From: Joseph, Stacy
Sent: Monday, June 20, 2011 7:18 AM
To: Gilmer, James; Wagage, Hanry; Makar, Gregory; Le, Tuan
Cc: Donoghue, Joseph; Norato, Michael; Hsia, Anthony; STPCOL
Subject: FW: ACRS Presentation
Attachments: Chapter 6 Followup Presentation JUne Rev.3-NRC.pdf

South Texas Project Units 3 & 4 Presentation to ACRS Subcommittee Chapter 6 Follow-up

Action Items Summary

Nukon Fiber Diameter

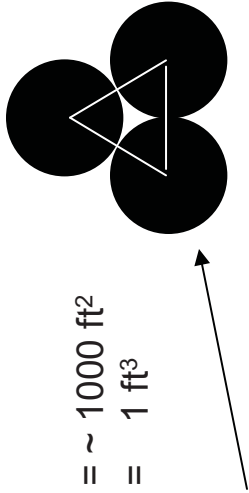
- Action Item # 74
 - *ACRS asked about the Nukon fiberglass fiber diameter*

- Diameter of fiberglass filaments
 - Range from 0.276×10^{-4} to 0.325×10^{-4} inches in diameter
 - Source: NEI 04-07
- Assuming;
 - Area of the STP 3&4 strainers
 - Fibrous debris
 - Fiberglass as surrogate fibrous debris
 - Uniform distribution of fibers over the strainer surface
 - “Worst case” (most dense) fiber packing (see diagram)
- Calculated bed thickness of fiberglass = ~ 0.01inches
- “Thin-bed” effect for fiberglass
 - Historically observed at a bed thickness = ~ 0.125 inches
for (NUREG/CR-6442)
 - STP 3&4 calculated thickness is more than an order of magnitude less than the historical
“thin-bed” thickness for fiberglass

Debris Addition Protocol

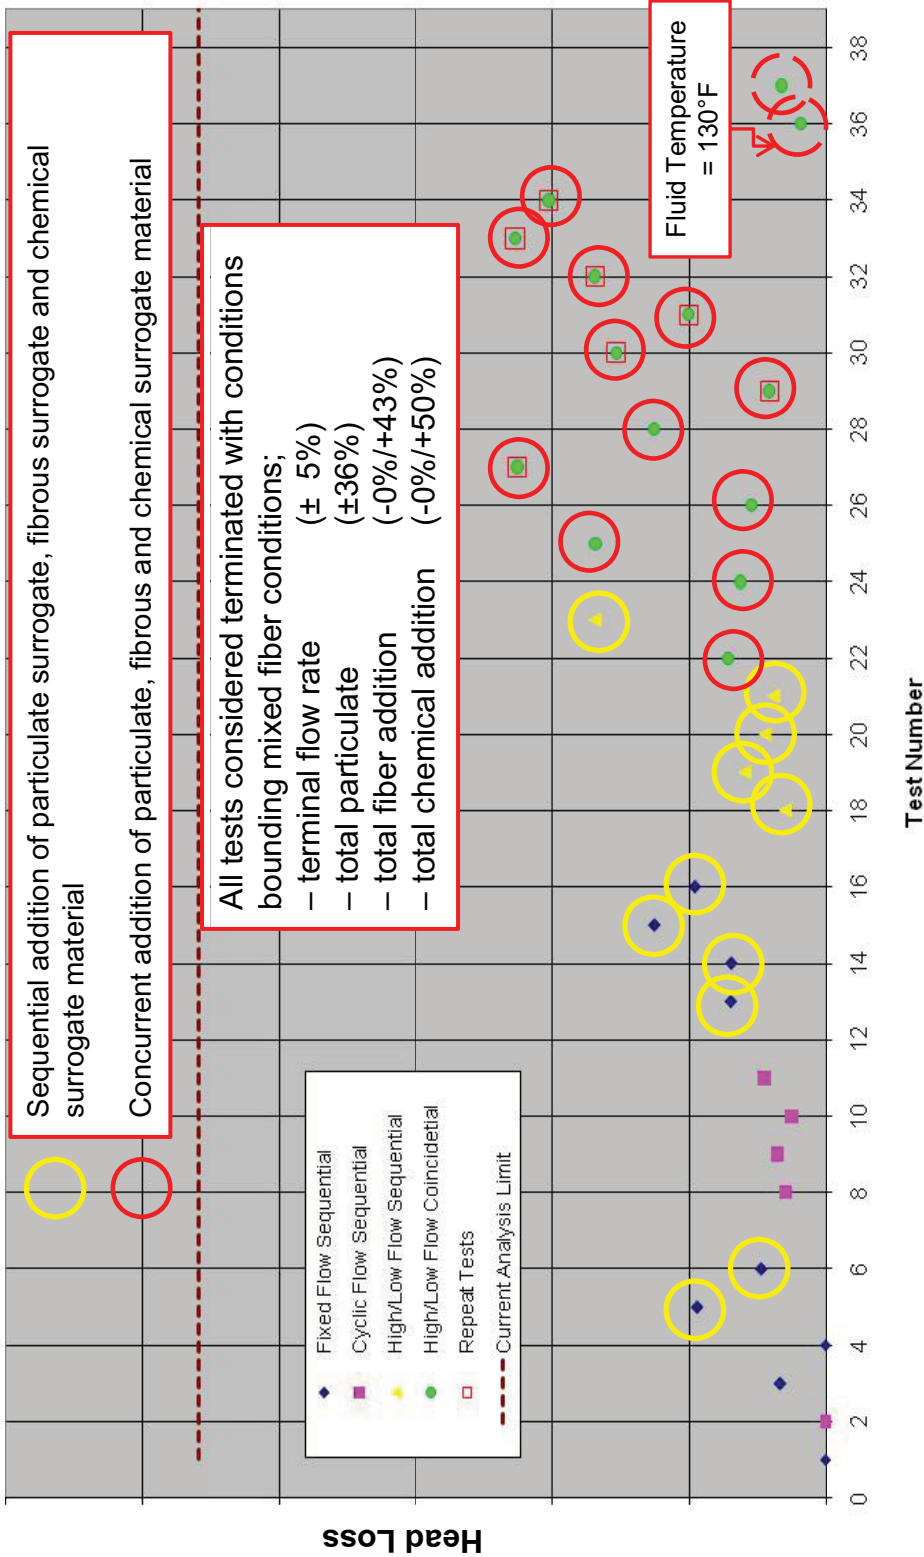
- Action Item # 79
- *ACRS challenged the use of the NRC-accepted protocol for addition of debris. It was stated that introduction of debris in different sequences may provide a worse result*

- PWR sump screen replacement testing indicated that the debris addition sequence of particulate first, fiber next, and chemical surrogates last was appropriate for testing for thin bed effects and produced the highest pressure drop across sump screens
- This protocol was mandated by the NRC for sump screen testing
- Since fuel is effectively another screen, this same protocol has been adopted for downstream fuel testing by the industry
- Another reactor design did test with concurrent addition of particulate and fiber
 - Observed pressure drops were within the range of test variability
 - It is concluded that this difference is within the variability of this type of testing
- Use NRC mandated protocol unless future industry downstream testing experience dictates otherwise

Hot Assembly Flow vs. Blockage Factor

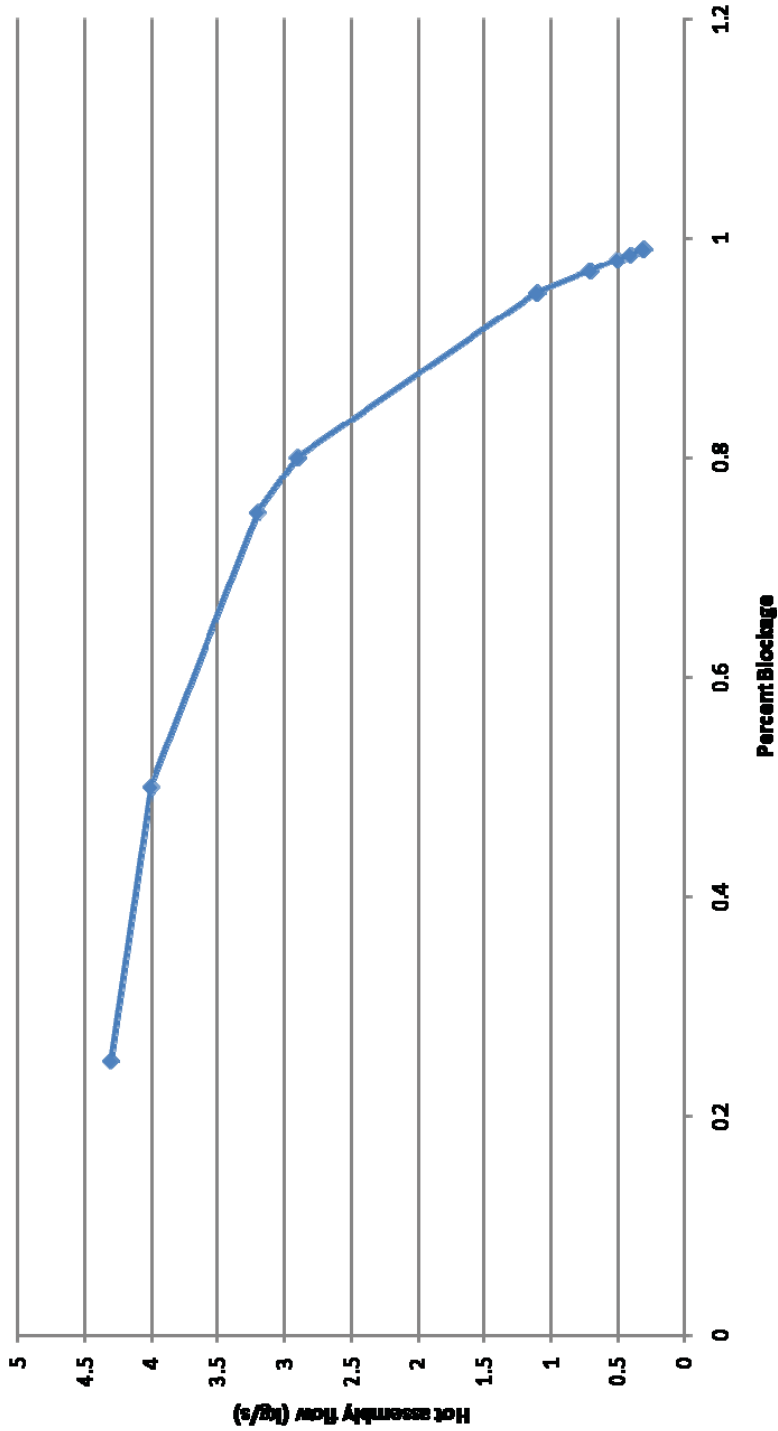
- Action Item # 84
- *ACRS requested a parametric study of k-factor vs. flow rate*

- Parametric study using the GOBLIN model employed for the acceptance criteria determination
- The inlet area of the hot assembly was reduced in stages to simulate blockage and the flow in the hot assembly was recorded (first plot)
- The second plot provides flow versus an equivalent K-factor
- There was no increase in PCT for any of these blockages

Fibrous Insulation as Surrogate for “latent fiber”

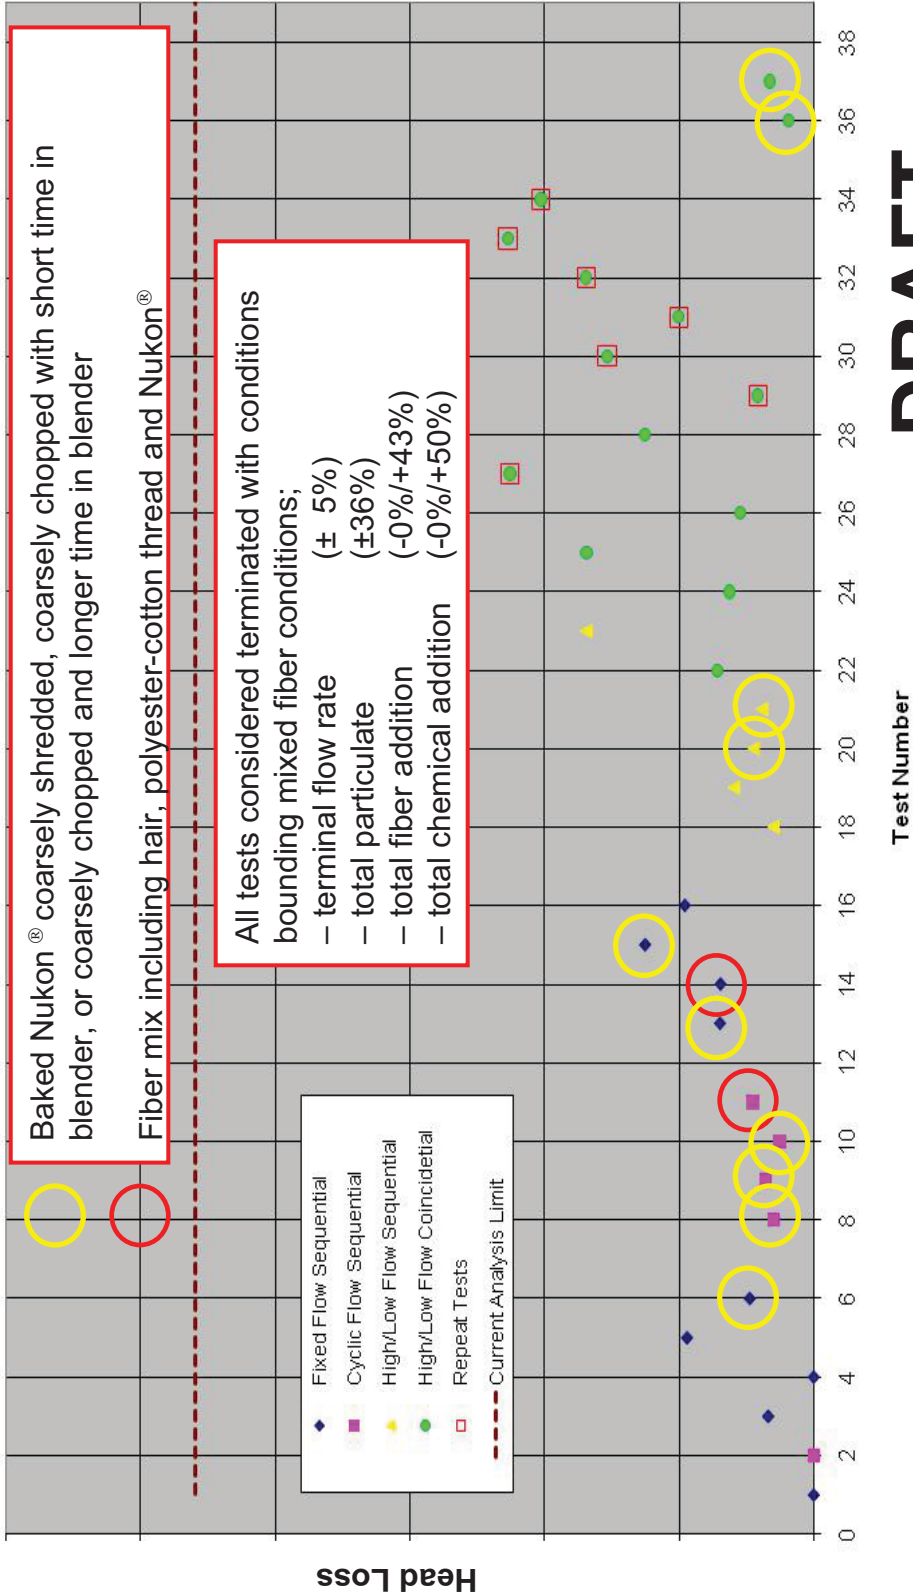
- *ACRS questioned the nature of the fiber proposed for the testing*

- Low-density fiberglass is used by the industry as a surrogate because it has superior strength compared to hair, dust-bunnies, and dust from protective clothing
- It is more likely to form a debris bed that will not collapse or dissolve due to the hydraulic load of flow through the debris bed
- Fiberglass has been observed to produce thin-bed pressure drop effects at small thicknesses compared to other fibrous materials such as mineral wool
- Testing performed for another advanced plant design has shown little difference in testing with fiberglass or with mixed fibers (hair, polyester-cotton, fiberglass) (see graph on following overhead)
- NINA will use fiberglass as surrogate for “latent fiber”, unless future industry downstream testing experience dictates otherwise
